Project	IEEE 802.16 Broadband Wireless Access Working Group http://ieee802.org/16 >	
Title	Comments on the network architecture of SDD	
Date Submitted	2008-03-10	
Source(s)	() , & & ,	Voice: +886-2-66000100 E-mail: loa@iii.org.tw
	Institute for Information Industry 7F, No. 133, Sec. 4, Minsheng E. Rd., Taipei City 105, Taiwan	* <http: affiliationfaq.html="" faqs="" standards.ieee.org=""></http:>
Re:	IEEE 802.16m-08/005- Call for Contributions on Project 802.16m System Description Document (SDD) Topic: Comments on IEEE 802.16m-08/003	
Abstract	This contribution proposes modifications to 16m network architecture to provide legacy support and enable the multihop relay.	
Purpose	For discussion and approval by IEEE 802.16 Working Group	
Notice	This document does not represent the agreed views of the IEEE 802.16 Working Group or any of its subgroups. It represents only the views of the participants listed in the "Source(s)" field above. It is offered as a basis for discussion. It is not binding on the contributor(s), who reserve(s) the right to add, amend or withdraw material contained herein.

Comments on the network architecture of SDD

Figure 2 The Relay Station in overall network architecture

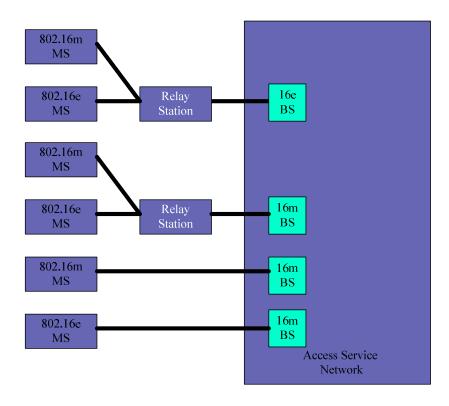
This contribution proposes modifications to 16m network architecture to provide legacy support and enable the multihop relay. In order to facilitate the incorporation of this proposal into SDD, specific changes to SDD are listed below.

[Modify Figure 2 in Line 22, Page 7 as follows:]
